Product Discontinuation

PDN-PS-6196-2020

Business Unit	Product Line Code	Type of Change	Action	Date of Issue
PS - Power Supplies	CMU	Product Discontinuation	Notify Distributors and Field	11/2/2020

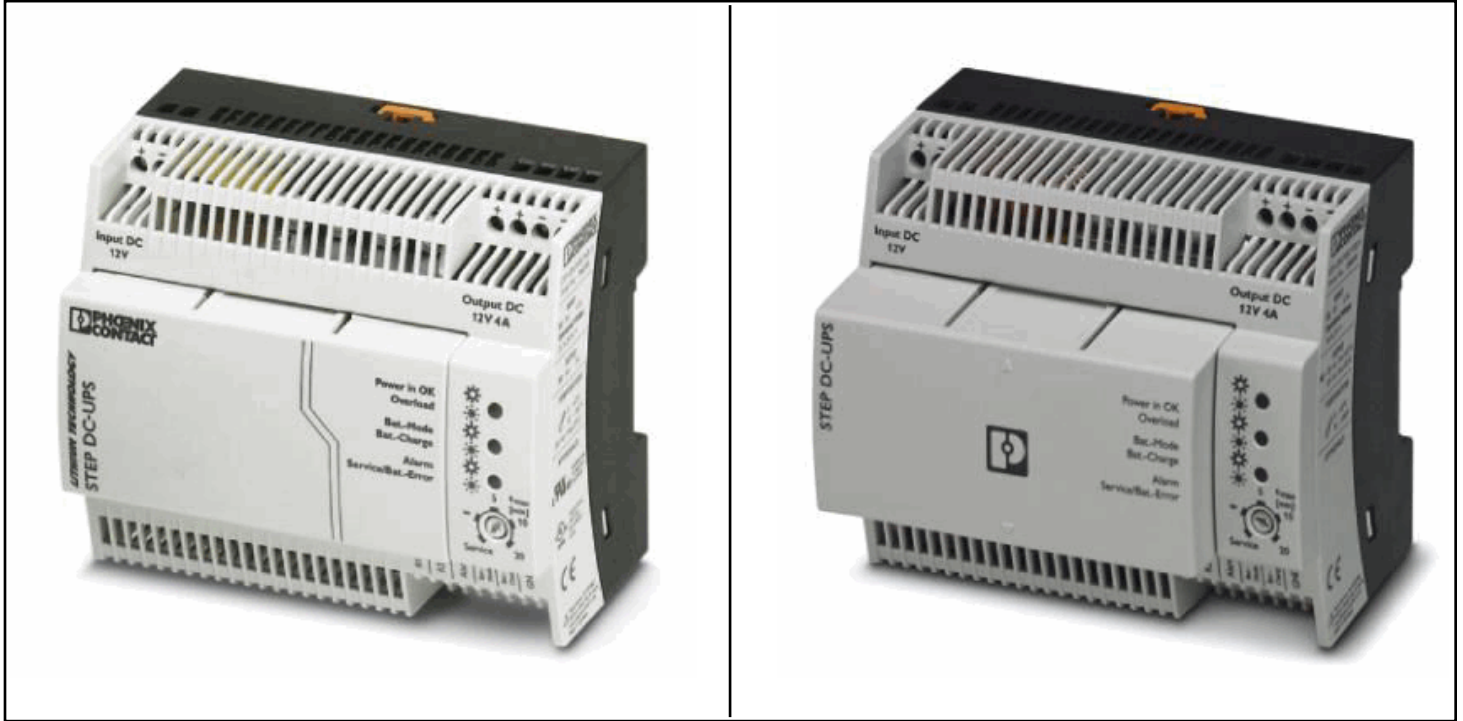
The manufacturer for the batteries used in the STEP-UPS/... products has discontinued production of the battery cells. The attached list of replacement products are available from inventory.

The new battery used provides 70% more storage capacity with only an increase of 10mm in depth.

Discontinued Part #	Type Description	Replacement Part #	Type Description
2320364	STEP-BAT/LIPO/18.5DC/1.4AH	1081355	STEP-BAT/LI-ION/18.5DC/46WH
2868703	STEP-UPS/24DC/24DC/3	1081430	STEP-UPS/24DC/24DC/3/46WH
2868693	STEP-UPS/12DC/12DC/4	1082548	STEP-UPS/12DC/12DC/4/46WH
